Re: Turkey Point Unit 3 and Unit 4
Docket Nos. 50-250 and 50-251
Florida Power and Light Company's, Turkey Point Units 3 and 4, First Six-Month Status Report in Response to March 12, 2012 Commission Order Modifying Licenses with Regard to Requirements for Mitigation Strategies for Beyond-Design-Basis External Events (Order Number EA-12-049)

First Six Month Status Report for the Implementation of Order EA-12-049

Modifications Nos. 2 and 3

Modification No. 2 (Unit 3 Shown, Unit 4 similar)
 Modification No. 3 has been eliminated

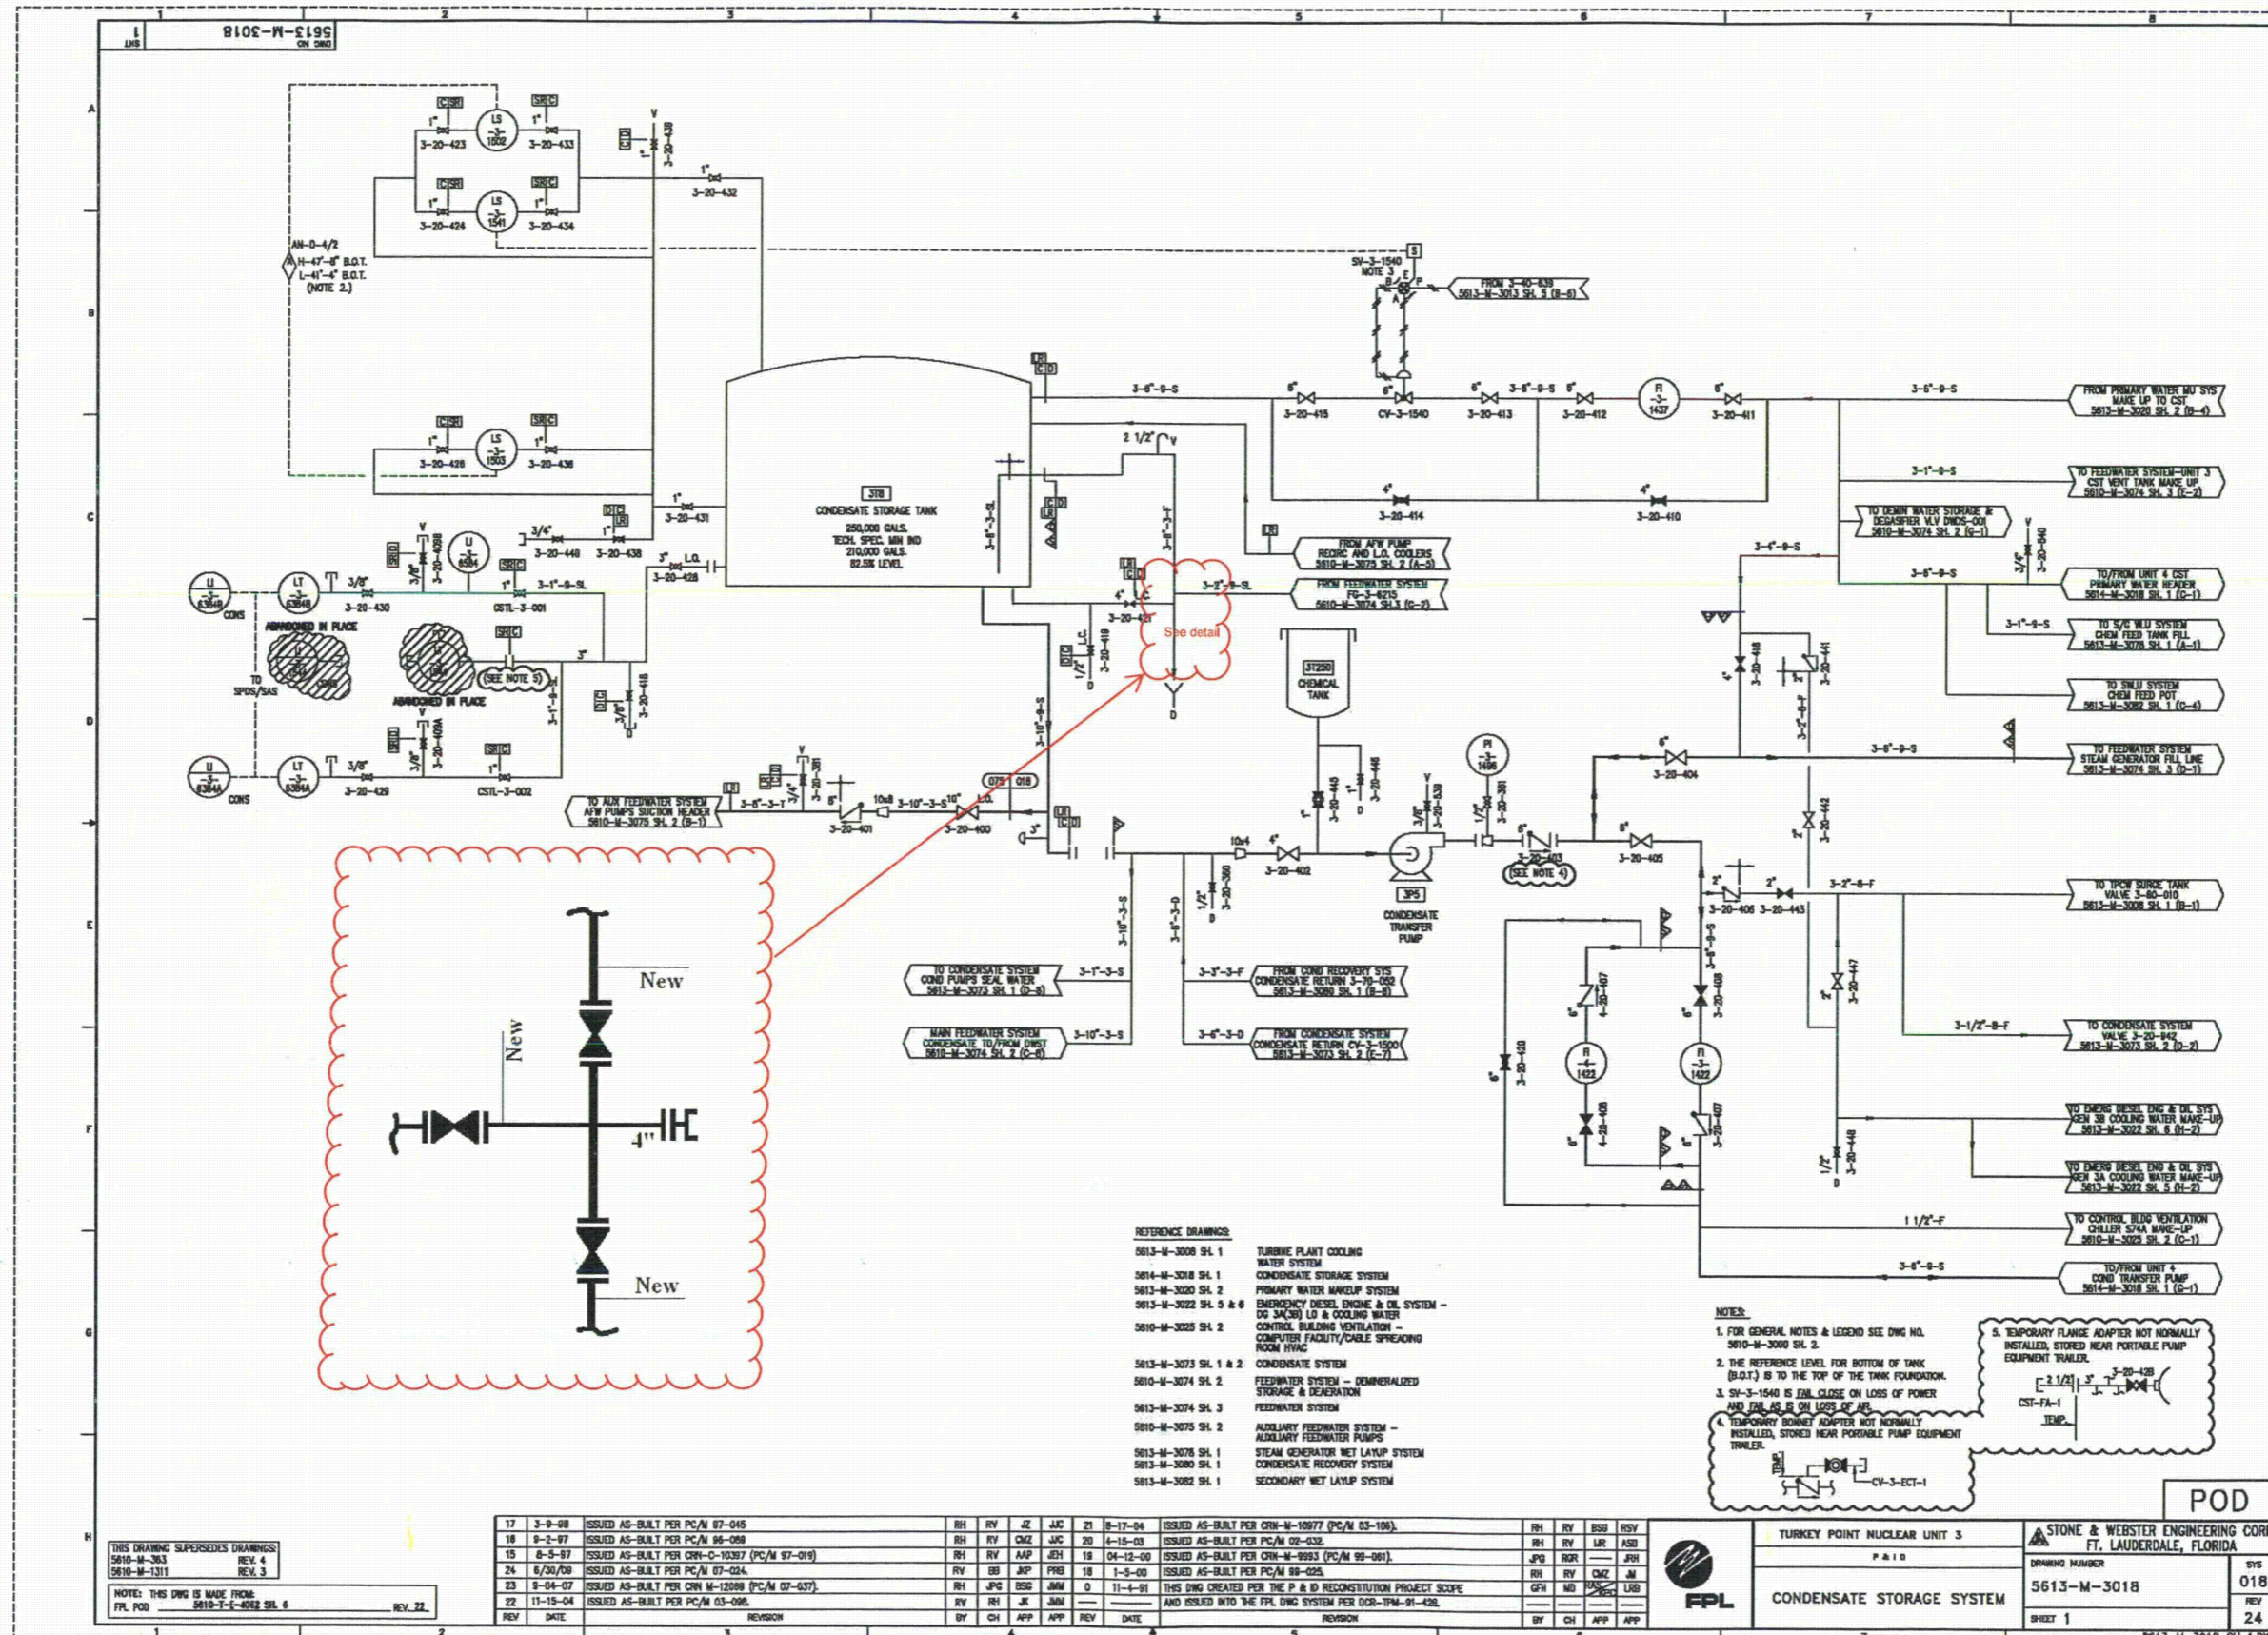
The Overall Integrated Plan submittal (Reference 1, Attachment 4) included a sketch showing three new hose connection points to the Condensate Storage Tank (CST) for use during Phase 2 (Modification Nos. 2, 3 and 4). The current plans are to install two connections (primary and alternate) which are sufficient to meet NEI 12-06 guidance. Modification No. 3 which previously added a hose connection and isolation valve to the CST manway has been eliminated. Modification No. 2 previously identified adding a hose connection and valve at the AFW suction line from the CST but, due to constructability and operational concerns, the connection point has been moved to the CST overflow drain line. Modification No. 4 has not changed. The two hose connections to the CST are designated as the primary and alternate connections for filling the CST and for supplying suction to the SG FLEX pump. Each of the connections will have Y hose connections to allow use for either flow path. A revised conceptual modification sketch has been provided in Attachment 1. This change will not affect the strategy or ability to maintain core cooling and heat removal by equipment credited during Phase 2.

Modification No. 6 (Unit 3 Shown, Unit 4 similar)

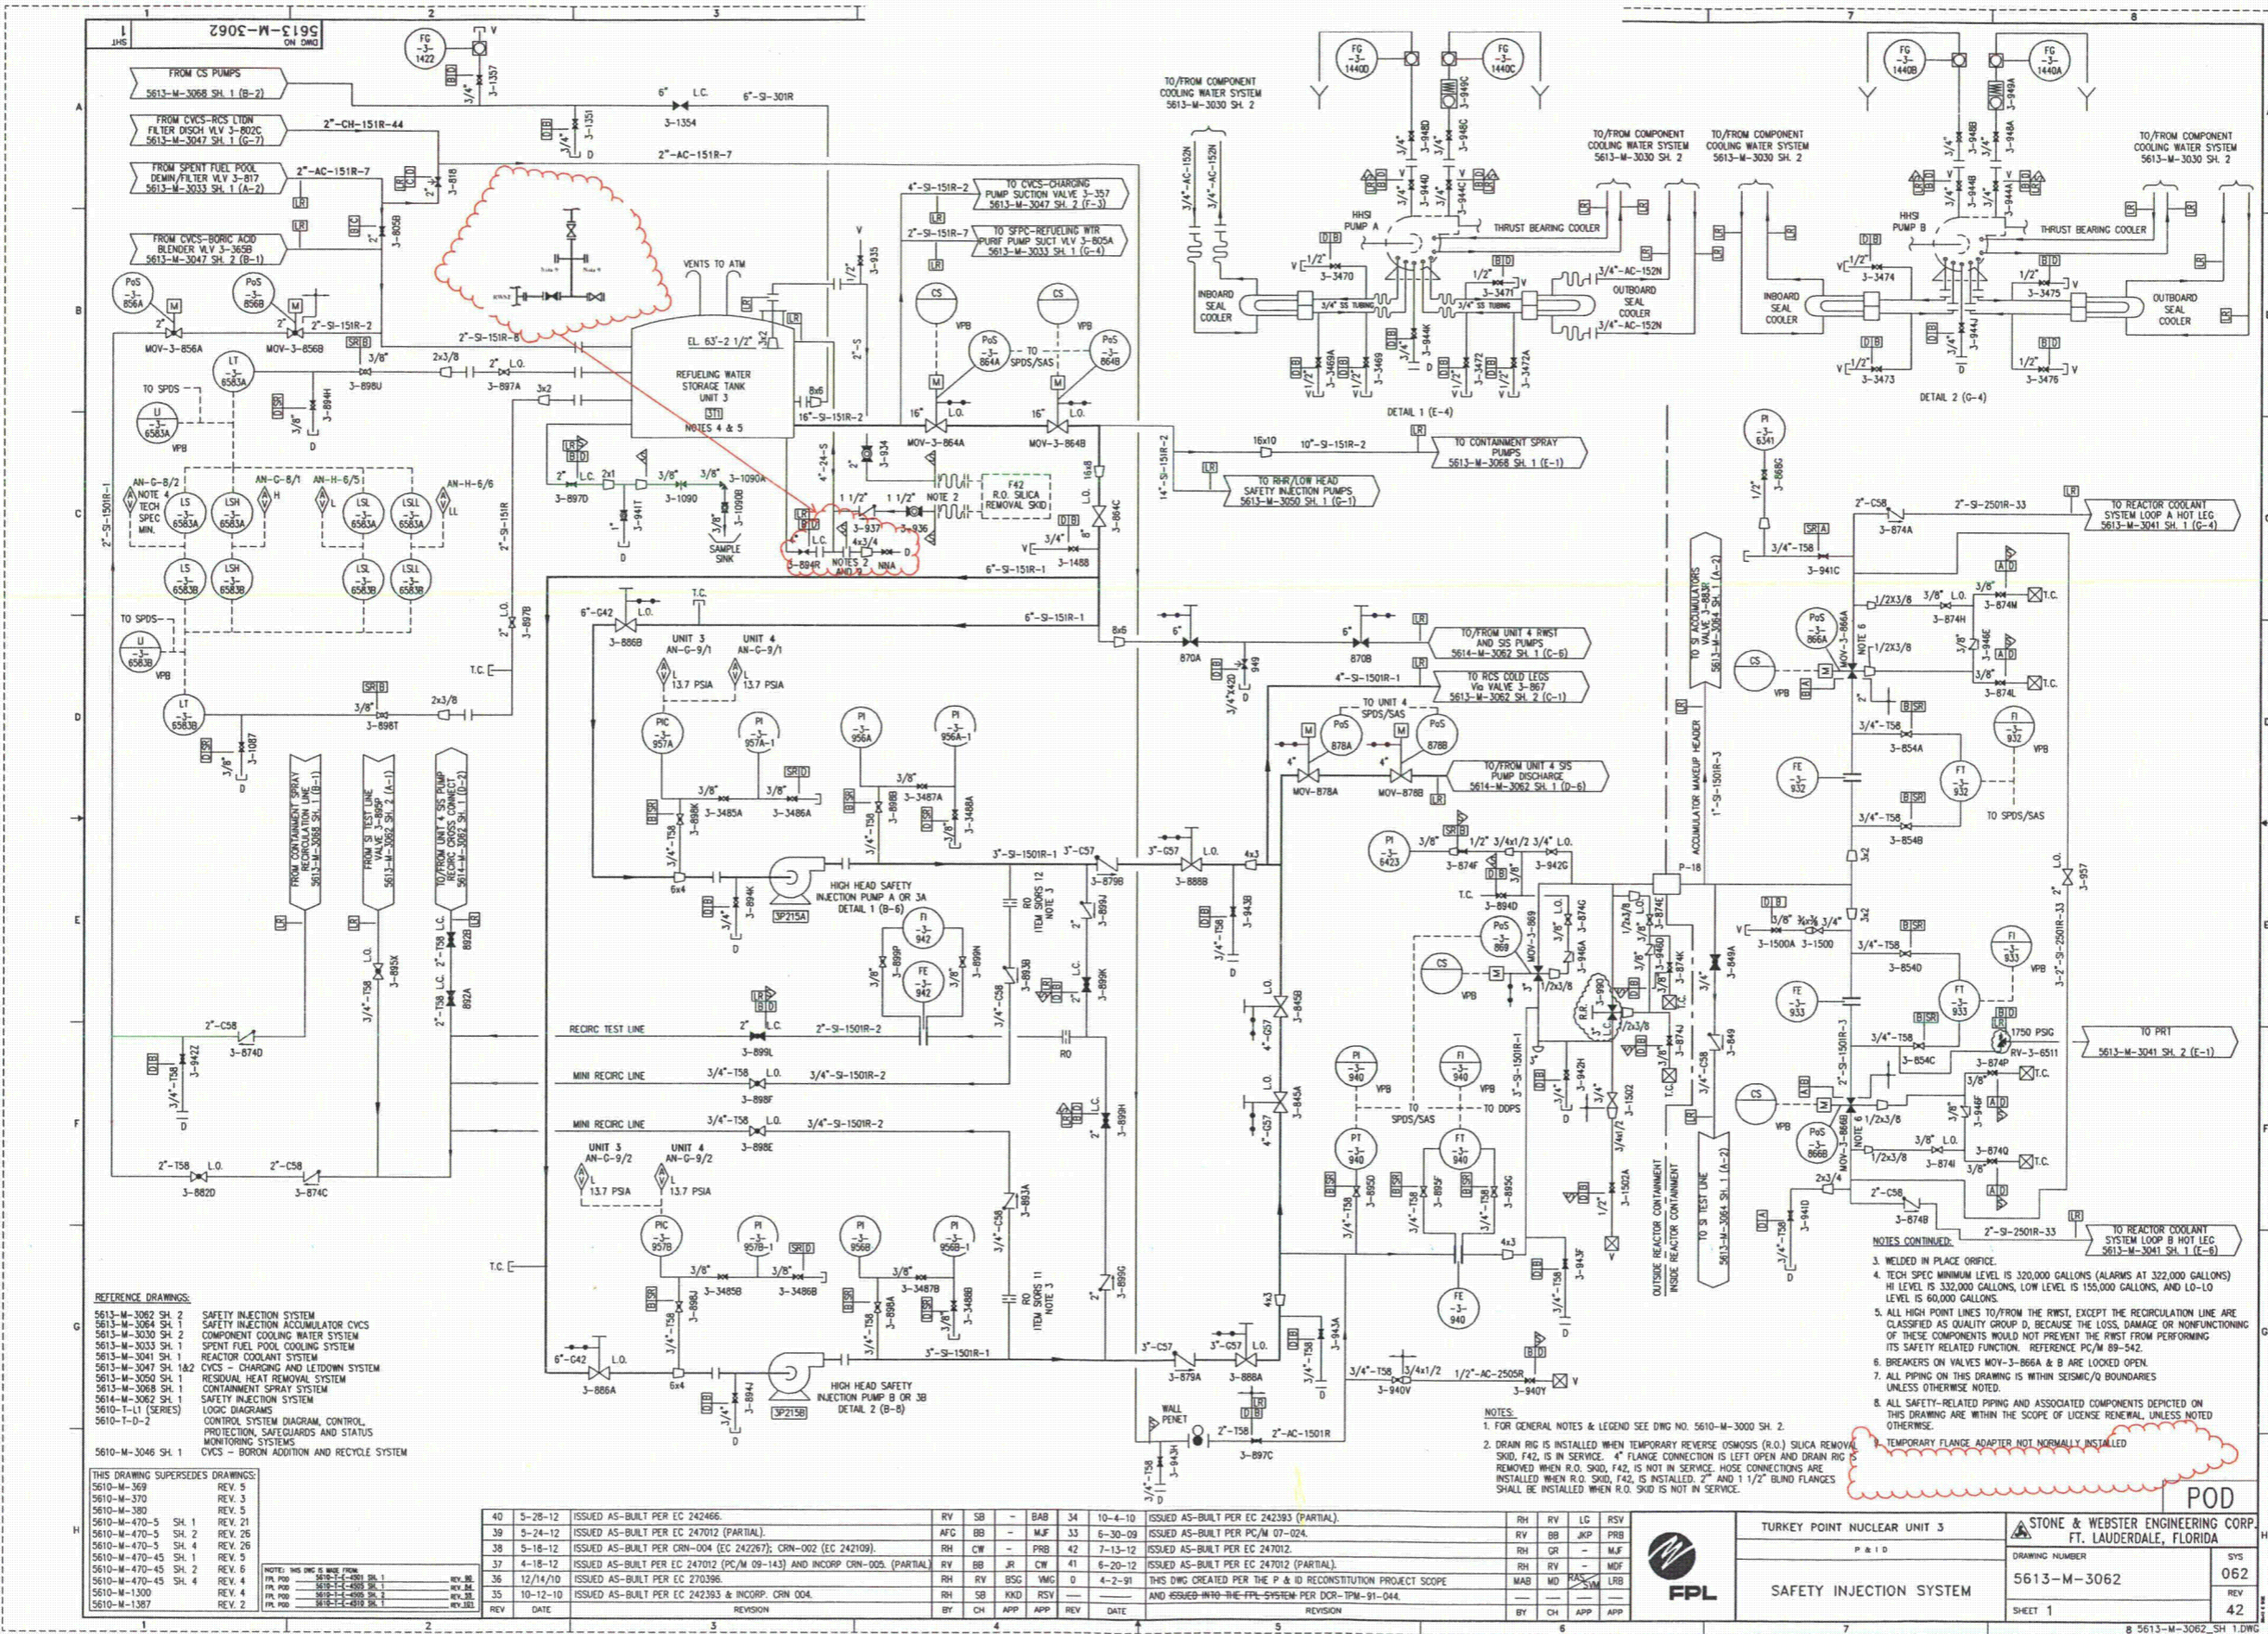
The Overall Integrated Plan submittal (Reference 1, Attachment 4) included a sketch showing a new hose connection point to the Refueling Water Storage Tank (RWST) manway cover for use during Phase 2 (Modification No. 6). Due to constructability and operational concerns, the current plans are to install a hose connection and isolation valve at the RWST overflow drain line. A revised conceptual modification sketch has been provided in Attachment 2. This change will not affect the strategy or ability to provide reactor coolant system inventory makeup by equipment credited during Phase 2.
